Service Information

STUDER Autolocator

Modifikation
Modification

SI 147/91

FIGURE 1: PUSH BUTTONS

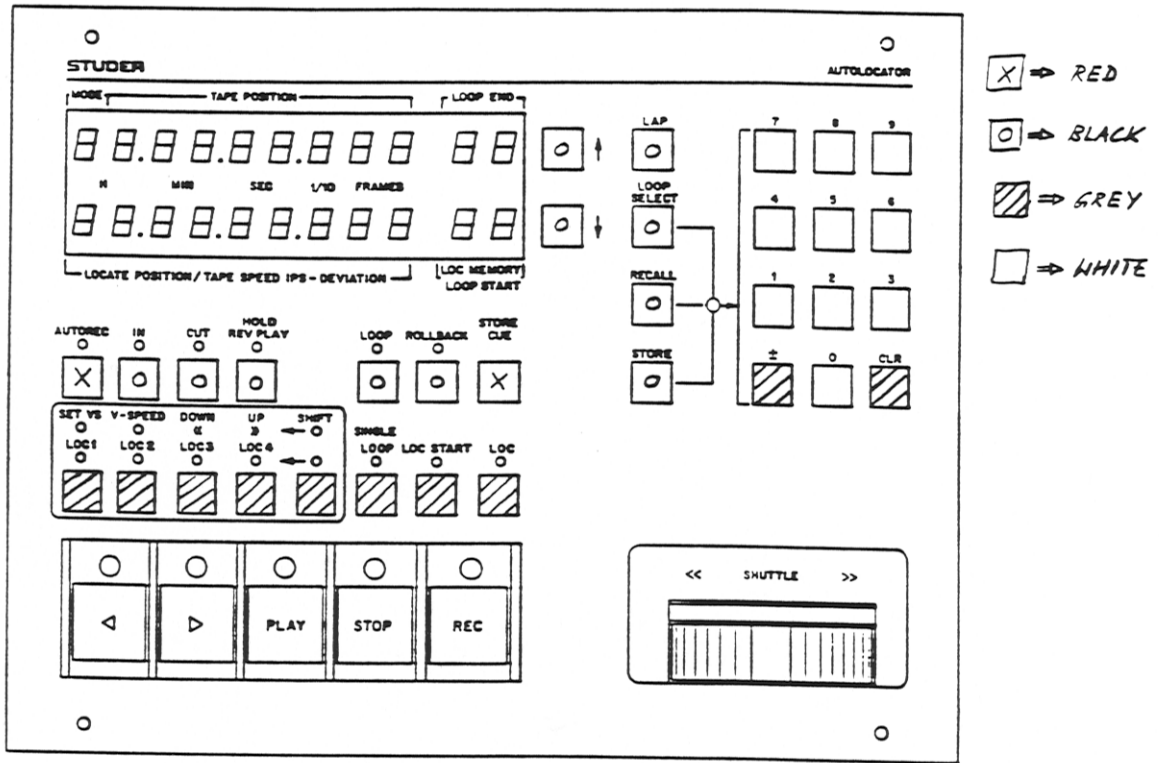
- Tastenkappen abnehmen und nach Figur 1 Neubestücken
- Karte 1.328.231.00 wieder montieren
- Tastenmechanik zusammen mit Karte 1.328.233.82 nach Figur 2 montieren

- Remove the PUSH-BUTTON/DISPLAY BOARD 1.328.231.00 (8x2,5 mm allen screw)
- Lift-off the caps from the switches and replace them as shown in figure 1
- Install the board 1.328.231.00 again

FIGURE 2: MECHANICAL MODIFICATION

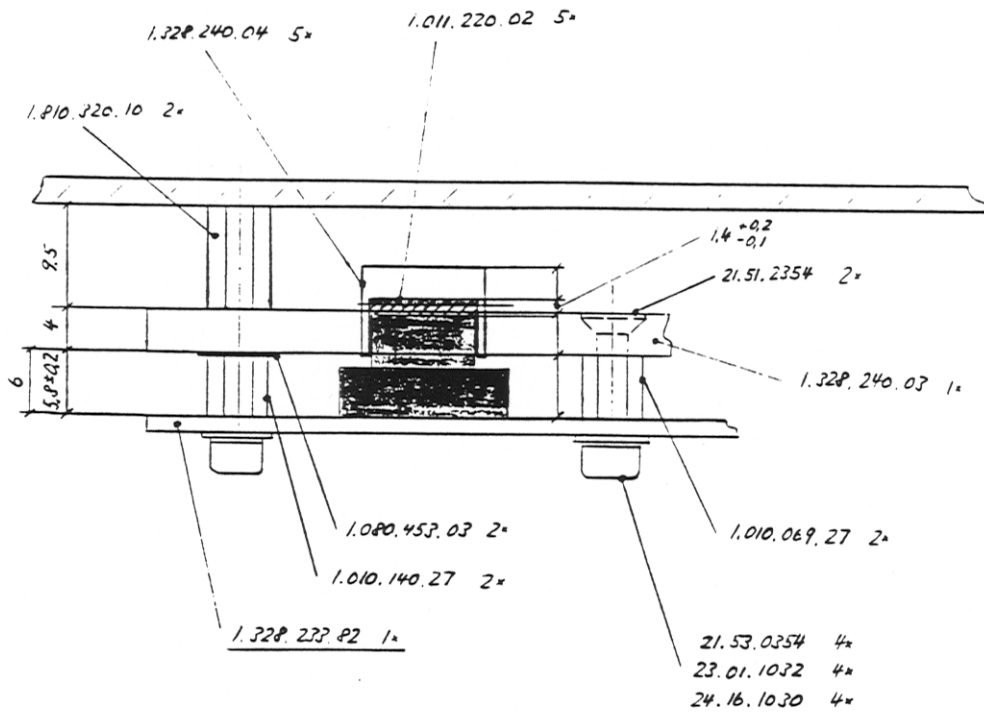
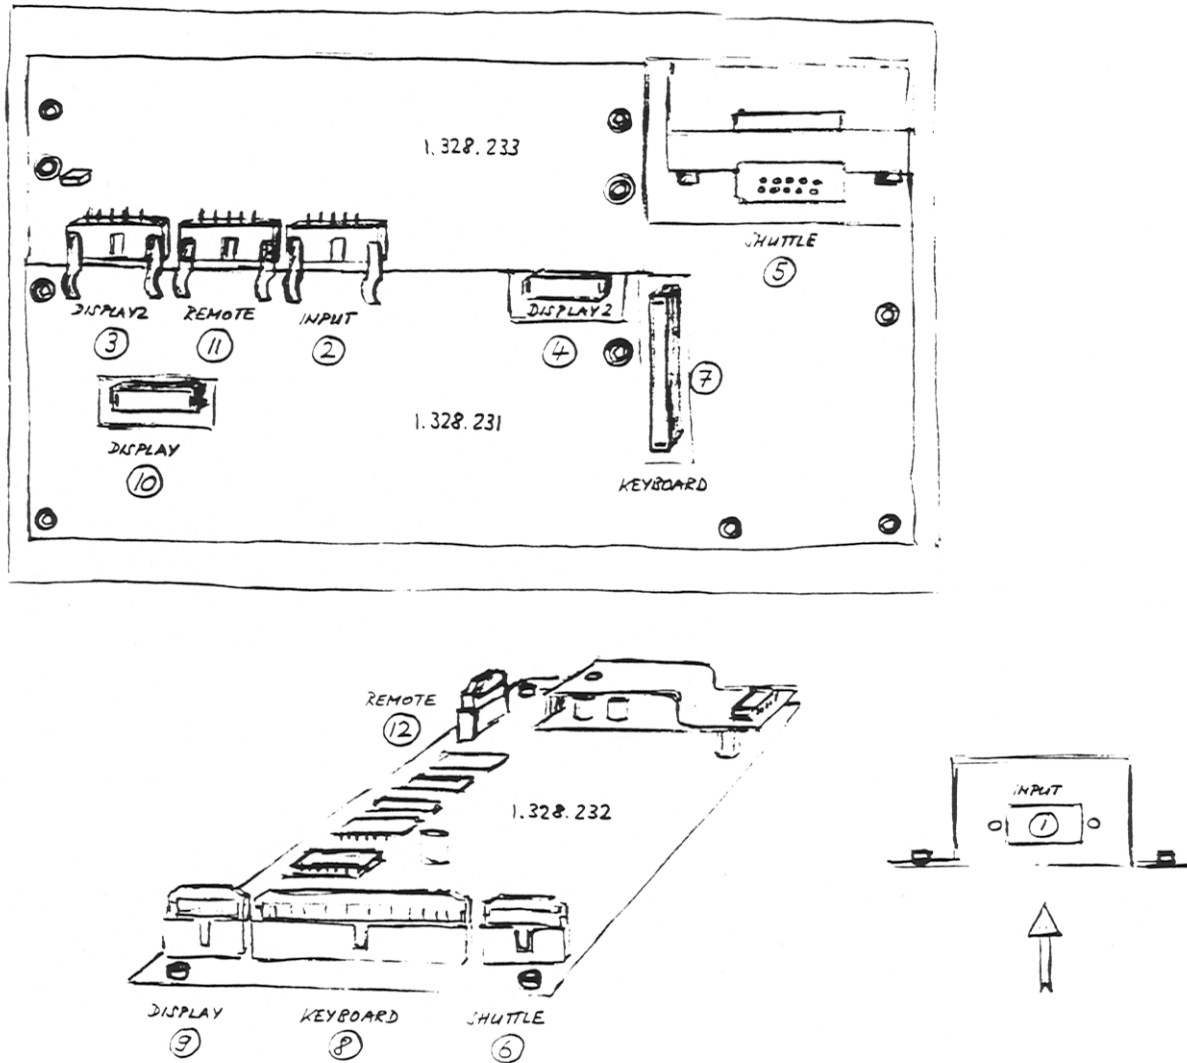
- Assemble the new PUSH-BUTTON BOARD together with the new mechanical extension to one unit and install it as shown in figure 2
- Remove the board 1.328.232 by unfasten the four 2 mm allen screws from the outside of the autolocator box
